**Economic and Social Council**Distr.: General
11 August 2023

World Forum for Harmonization of Vehicle Regulations**Working Party on Lighting and Light-Signalling****Eighty-ninth session**

UN Regulation No. 10 (Electromagnetic Compatibility)**Proposal for a new 07 series of amendments to UN Regulation No. 10 (Electromagnetic compatibility)****Submitted by the expert from by the Informal Working Group on Electromagnetic Compatibility***

The text reproduced below was prepared by the experts from the Informal Working Group on Electromagnetic Compatibility (IWG EMC), with the aim to develop a new 07 series of amendments to UN Regulation No.10. The proposed modifications to the current text of the UN Regulation are marked in bold for new or strikethrough for deleted characters.

"Figure 1b

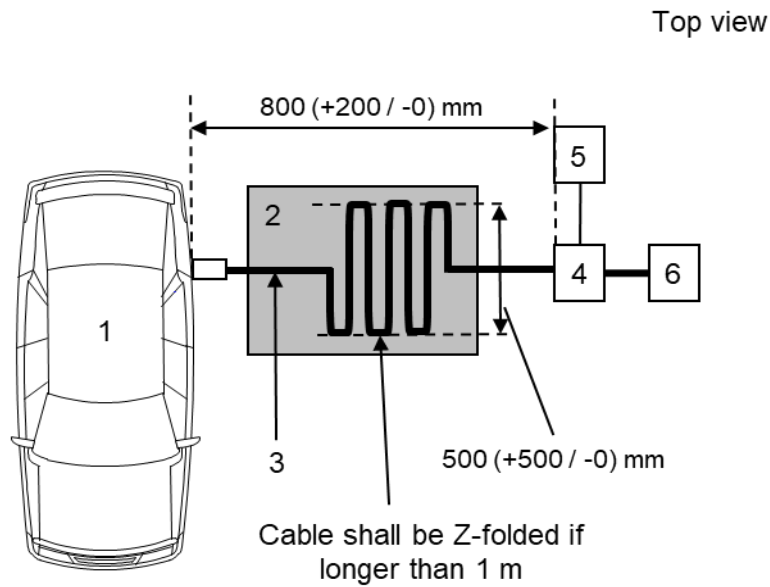
Figure 1b, amend to read:

"Figure 1d

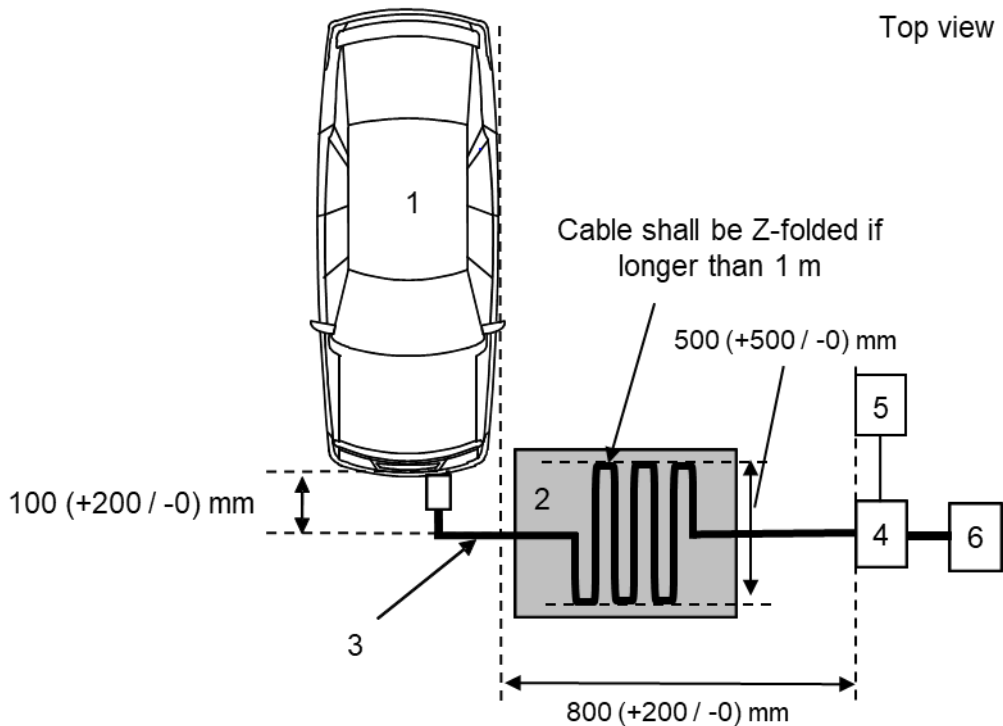
Figure 1d, amend to read:
